MINUTES
**BOARD OF BUILDING STANDARDS/
ARCHITECTURAL BOARD OF REVIEW/SIGN REVIEW**
REVIEW MEETING
CITY OF LAKEWOOD
12650 DETROIT AVENUE
AUDITORIUM
SEPTEMBER 8, 2022
5:30 P.M.
PARTIALLY RECORDED MEETING
<https://www.lakewoodoh.gov/videos-2/>

2. APPROVE THE MINUTES OF THE AUGUST 11, 2022 MEETING

Docket No. 08-52-22 (13429 Cliff)
Porch Addition

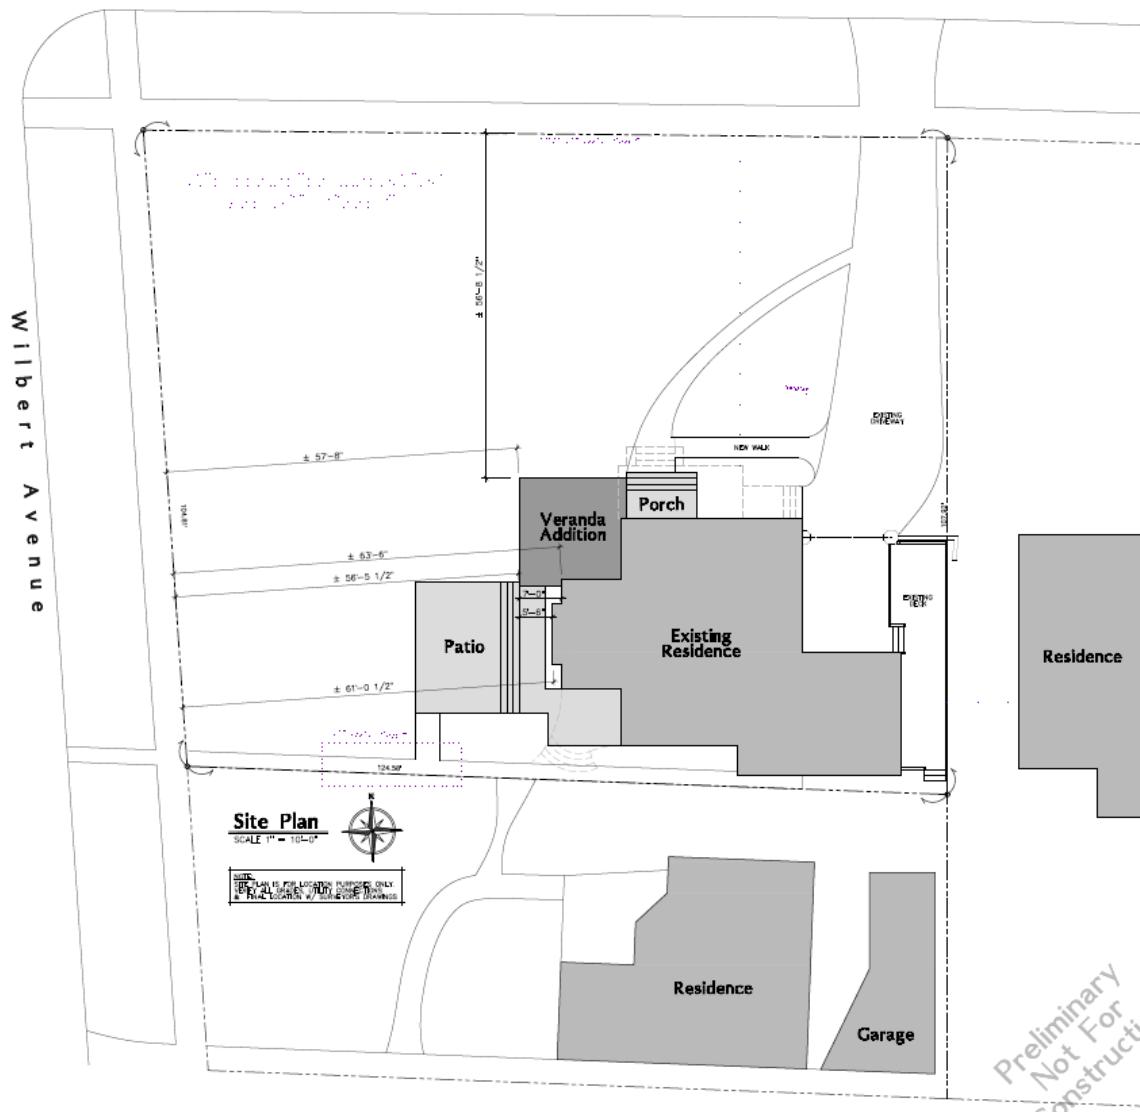
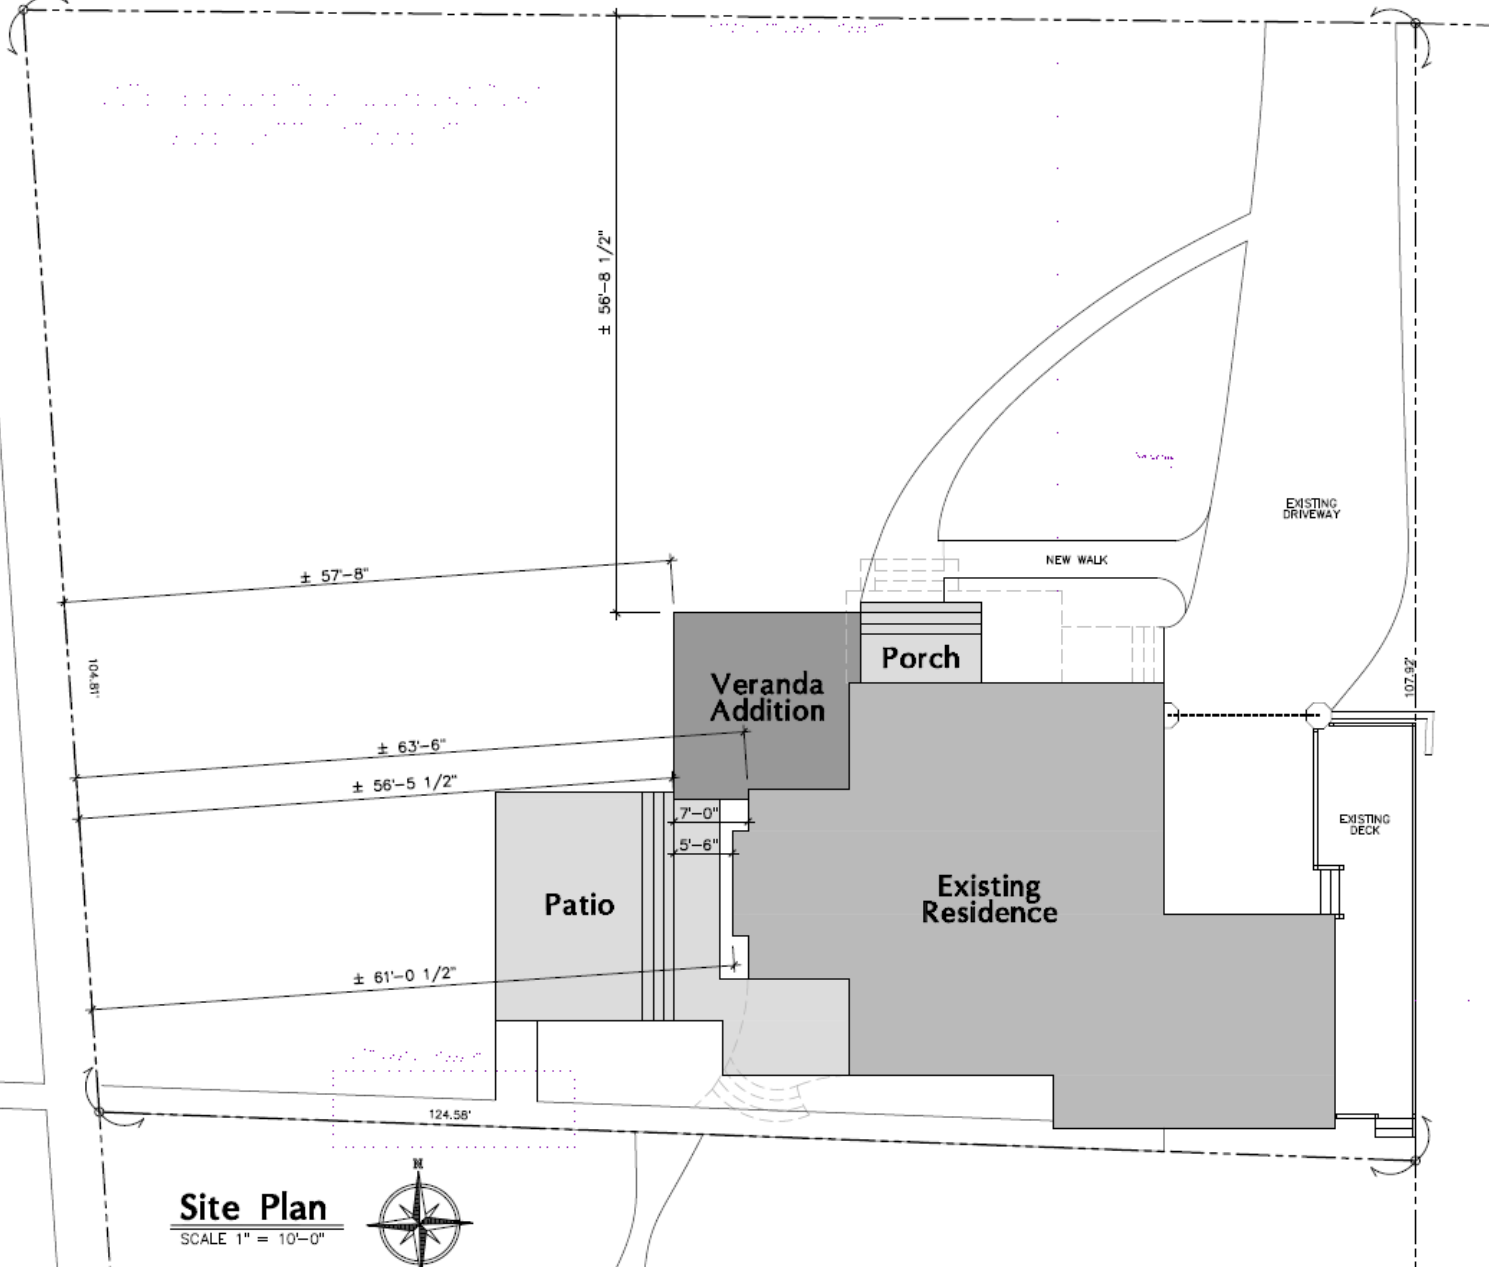
- Should the new patio be built as proposed, and given the positioning of the yard, the house and the afternoon summer sun, the new owner will find the afternoon and early evening summer sun on the west side of the house, and on the proposed patio, to be intense. Residents on the east side of Wilbert whose front yards are in the afternoon summer sunshine routinely find themselves seeking shade. This observation is relevant because of the likelihood that once such a patio (raised or not) and deck are built, by this owner, or some future owner, they will seek to add some sort of sun protection, perhaps a structure or shade trees – each of which will further adversely impact neighbors all the way up the street.

We encourage the new owner and his/her architect to revise their plans in an effort to avoid breaking with the long tradition on Wilbert of protecting the lake view for all of its residents. As long-time residents of Wilbert, we are concerned that if these current plans are approved and completed as proposed, it will announce the end of the longtime practice on Wilbert of sharing and protecting the lake view, so that it can be enjoyed by the many, now and in the future, as opposed to the few, as is the case elsewhere.

Over 100 years ago Wilbert Road was planned, deliberately, to allow all residents of the street to have a visa to Lake Erie. This plan was executed with precision and has been respected and adhered to for over 100 years. The proposed expansion at 13429 Cliff Drive impacts the view corridor and sets a dangerous precedent that will lead to additional expansion into the view corridor. The proposed seven-foot extension of the home (referred to as the veranda in the drawings), and deck above, will negatively impact the Wilbert neighborhood view corridor. Wilbert is unique in that it is one of the few streets to have a lake view for all its pedestrians and residents. Any impairment of this visa, no matter how an individual property owner or architect considers insignificant, is a violation of the design integrity of the street and a disrespect to the history/future of the street and Wilbert neighbors. Over the years property owners have restrained from making any changes negatively impacting sight lines for their neighbors to the south. One change, while seemingly minor, will set in place a precedent that will forever change the nature of the street and Lakewood.

Docket No. 09-61-22 (1474 Riverside)
 Residential – New Garage + Porch Addition

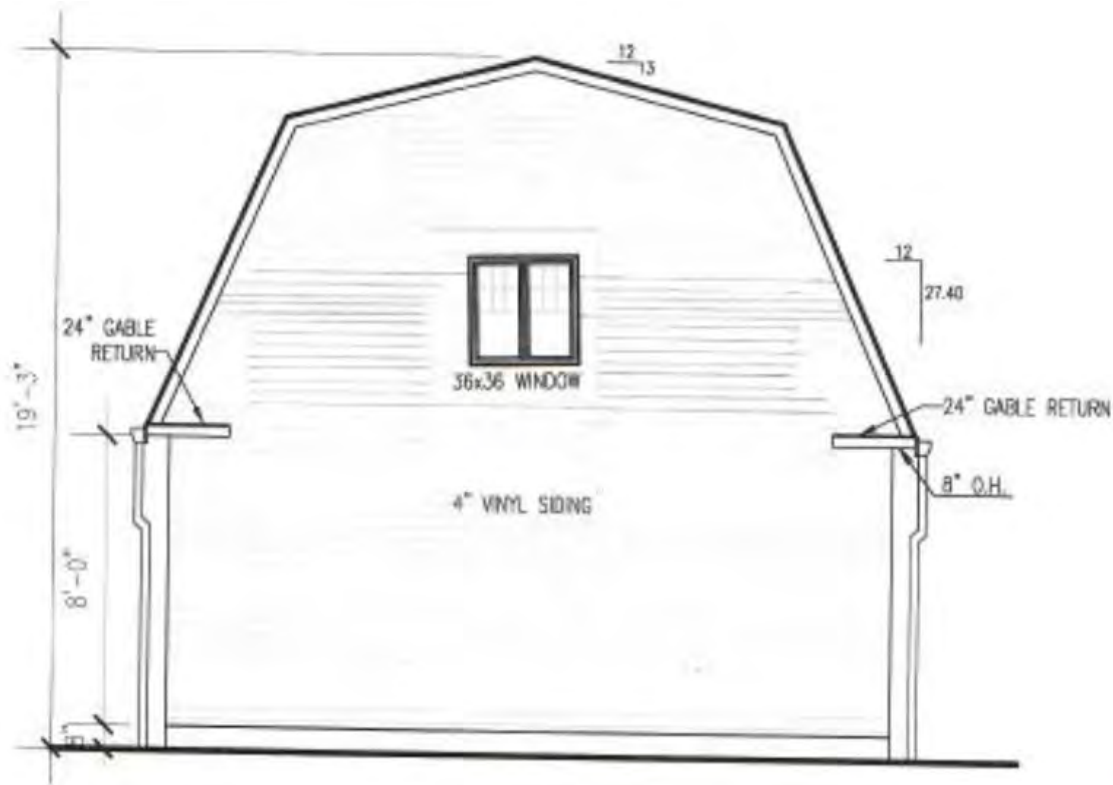
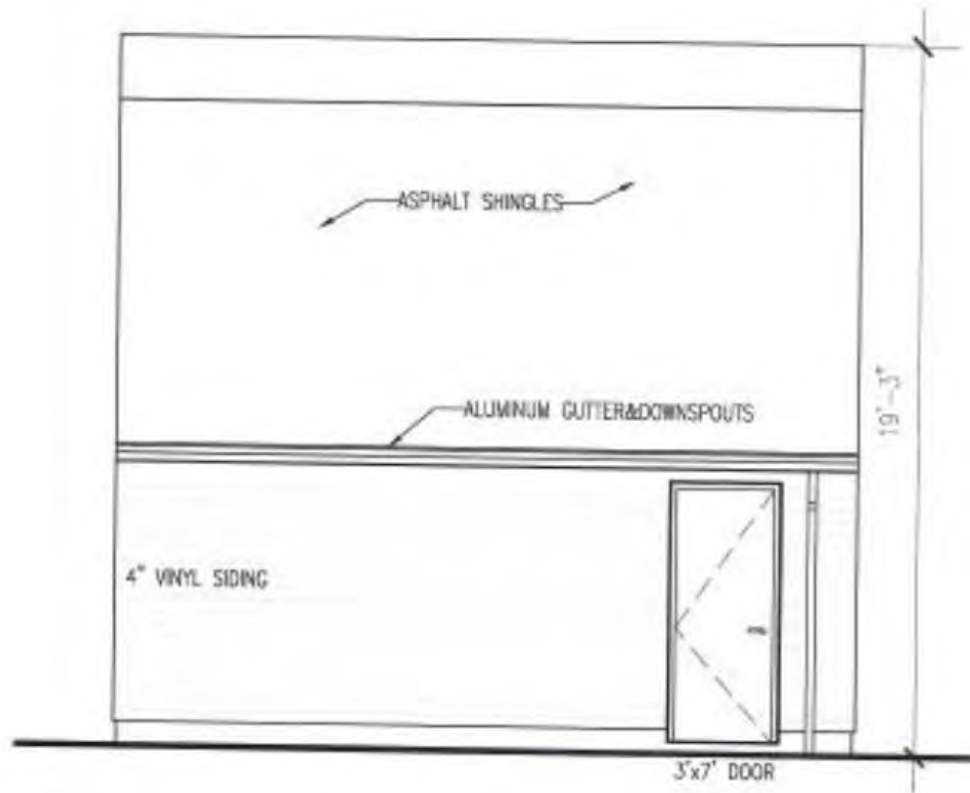
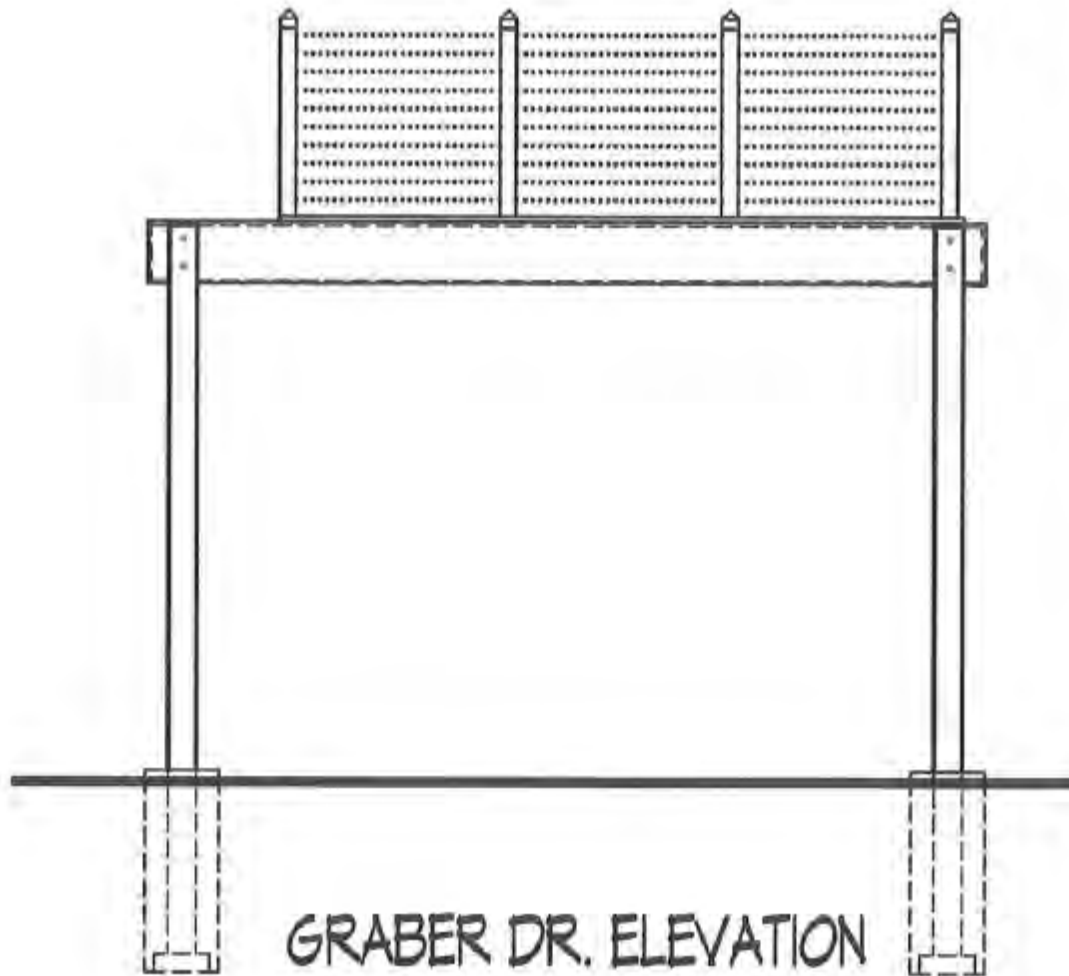
Nilsa Carren, Platinum Construction, representative was present to explain the request. The members said the rear elevation window was too small, the change to a Graber Dr. driveway entrance was better, the addition of corner boards, 24" gable returns on both sides (front and rear elevations). David Harala, Architect, was present to explain the request for an upper deck that was added to the proposal after the pre-review meeting. Staff stated the project would be heard by the Board of Zoning Appeals ("BZA") for approval of nine variances at its September 15, 2022 meeting. There was discussion about the irregularly shaped lot, the property line in relation to the sidewalk. The rendering was insufficient for the members to approve. (The recording ended here).
